**RE: Wilshire Place Subdivision
Conceptual Grading and Drainage Plan
Engineer's Stamp Date: 02/15/18
Hydrology File: C18D103**

Based upon the information provided in your submittal received 05/11/2018, the Conceptual Grading and Drainage Plan **is not** approved for action by the DRB for Preliminary Plat and Site Plan for Building Permit. The following comments need to be addressed for approval of the above referenced project:

Sheet Title
**DRAINAGE AND
CONCEPTUAL GRADING PLAN**
Date
FEBRUARY 15, 2018
Project No.

SP2

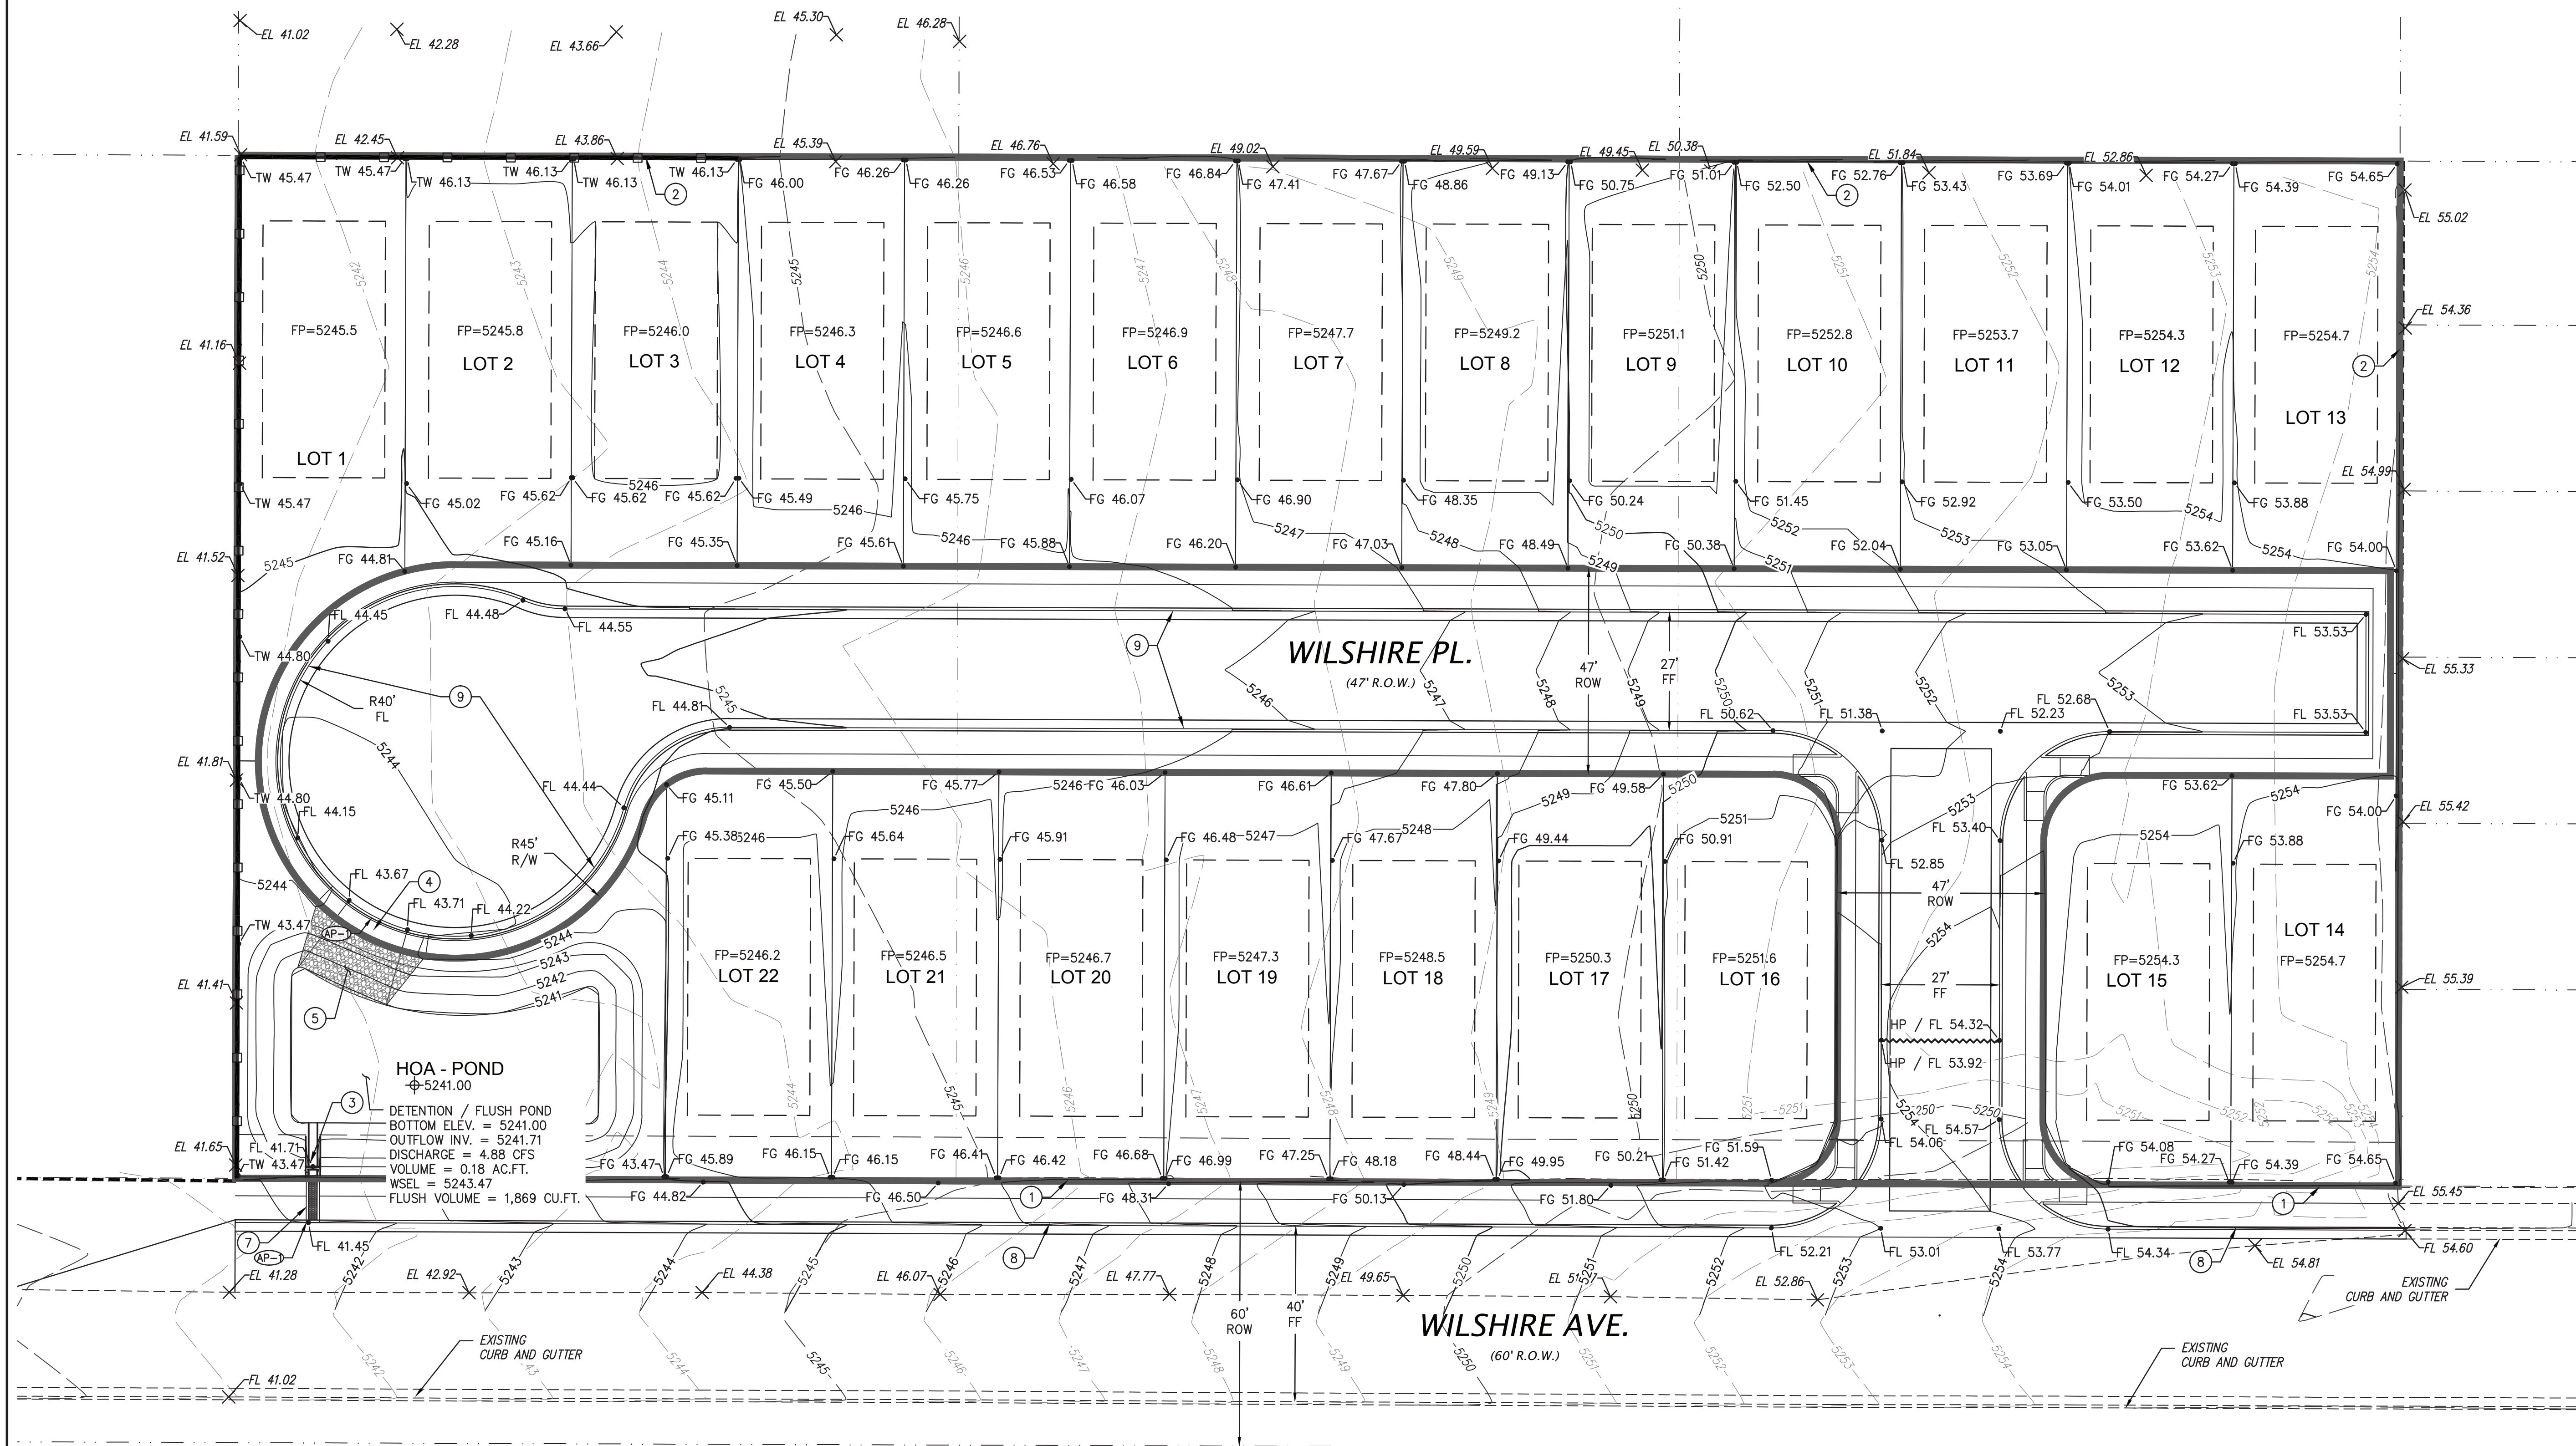
1. Please provide a vicinity map showing the location of the site.
2. Please provide the benchmark information for the survey contour information provided.
3. Please add a note that this site is within the North Albuquerque Acres Master Drainage Plan. This site has an allowable discharge of 3.47 cfs/ac. Therefore this 2.65 ac site can discharge 9.20 cfs.
